# Access Compliance Report

## Public Rights-of-Way

Intersection ID: 12370	Main Street: S_CLARKSON_ST	Cross Street: POST_ST	Location:	N
ADA ID: 4002D3C15E88	Ramp Type: BlendTrans1	Initial Pass/Fail: Fail	Overall Compliance: No	Severity Score: 10

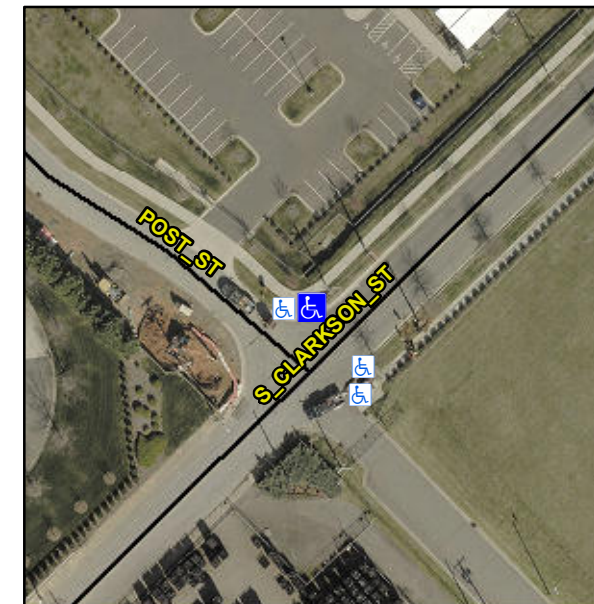
**Not Found, R304.5.1, R304.5.3**

Compliance	Description	Data	Compliance	Description	Data
N/A	Ramp Length (in)	96.0	Yes	BlendTrans Slope (%)	4.5
No	Ramp Width (in)	47.0	No	BlendTrans XSlope (%)	2.7
N/A	Flare Type LT	N/A	N/A	Flare Type RT	N/A
N/A	Flare Slope LT (%)	N/A	N/A	Flare Slope RT (%)	N/A
N/A	Flare Traversable LT?	N/A	N/A	Flare Traversable RT?	N/A
N/A	Landing Length (in)	N/A	N/A	DWS Provided?	N/A
N/A	Landing Width (in)	N/A	N/A	DWS Contrast?	N/A
N/A	Landing Slope (%)	N/A	N/A	DWS Length (in)	N/A
N/A	Landing X Slope (%)	N/A	N/A	DWS Full Width?	N/A
N/A	Landing Curb? (Y/N)	N/A	N/A	DWS Offset (in)	N/A
N/A	Shared Landing?	N/A			
N/A	Gutter Ponding?	N/A	N/A	Gutter Slope (%)	N/A
N/A	Gutter Lip Ht (in)	N/A	N/A	Gutter X Slope (%)	N/A
N/A	Painted X Walk1?	No	N/A	Painted X Walk2?	N/A
	X Walk 1 Direction	To SE		X Walk 2 Direction	N/A
	X Walk 1 Width (in)	N/A		X Walk 2 Width (in)	N/A
	X Walk 1 Slope (%)	3.4		X Walk 2 Slope (%)	N/A
	X Walk 1 X Slope (%)	1.6		X Walk 2 X Slope (%)	N/A

**Remove & Replace Curb Ramp With Two New Directional Ramps or Equivalent.**
